Re: CISC Technical Memorandum No. 5, 1985.02.22

Ultimate Compressive Capacity of a "K" Brace Connection Detail

CISC TECHNICAL MEMORANDUM NO. 5

Re: Ultimate Compressive Capacity of a 'K' Brace Connection Detail

SKETCH 'A'

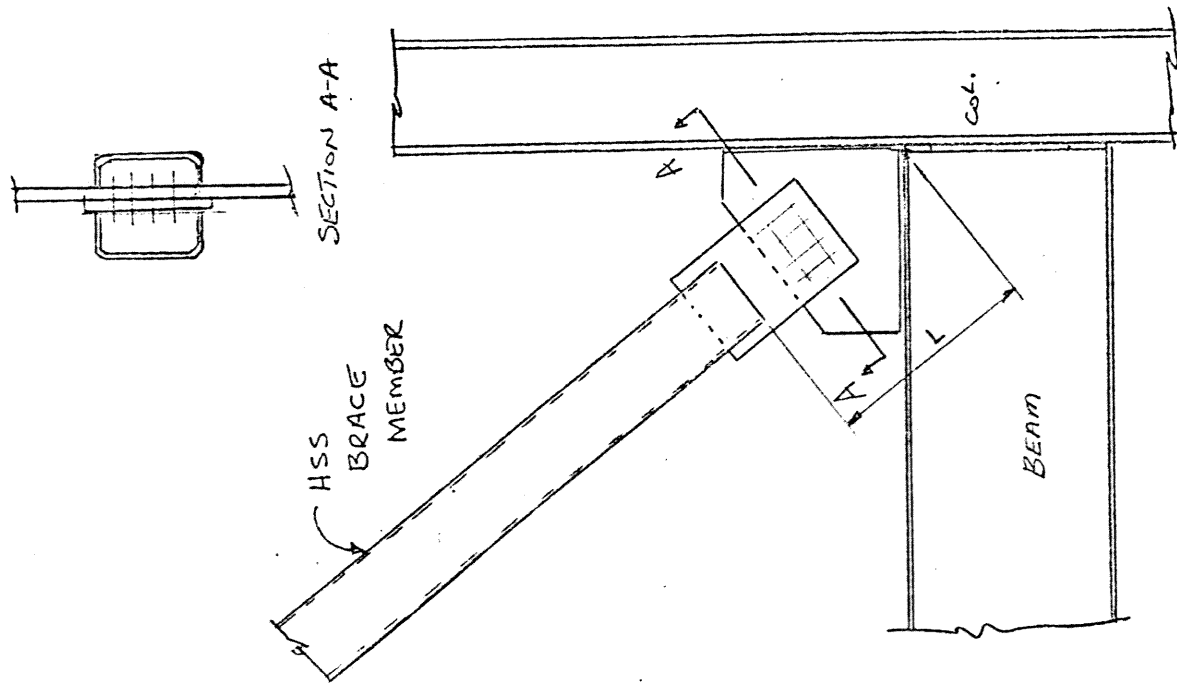
Sketch 'A' on the attached sheet shows part of a 'K' brace joint detail. The brace member is a large hollow structural section (HSS) and the connection consists of a flat plate welded into a slot in the HSS. The HSS and the connection plate are connected to the gusset plate at the beam-column joint with bolts in a simple lap splice.

Although this type of detail has been used successfully in 'X' bracing systems for tensile loads, its use in 'K' bracing under compressive loads had come under scrutiny. It has been reported that this detail has failed in compression in a structure in Canada. A detailed analysis, such as a finite element, together with an actual test of a full-size specimen have shown that using an effective length factor, K , of 1.2, a length, L , measured from the end of the tube to the point where the centre line meets the supporting beam or column flange, and designing the connection solely for axial load significantly overestimates the ultimate capacity of this detail. The actual failure load measured in the test was only 75% of the specified (working) load. Significant lateral deflection of the gusset plate at low loads was observed in the test due to the eccentric line of action of the forces.

Although specific design recommendations for the detail shown are not available at this time, the use of a stiffener is highly recommended.
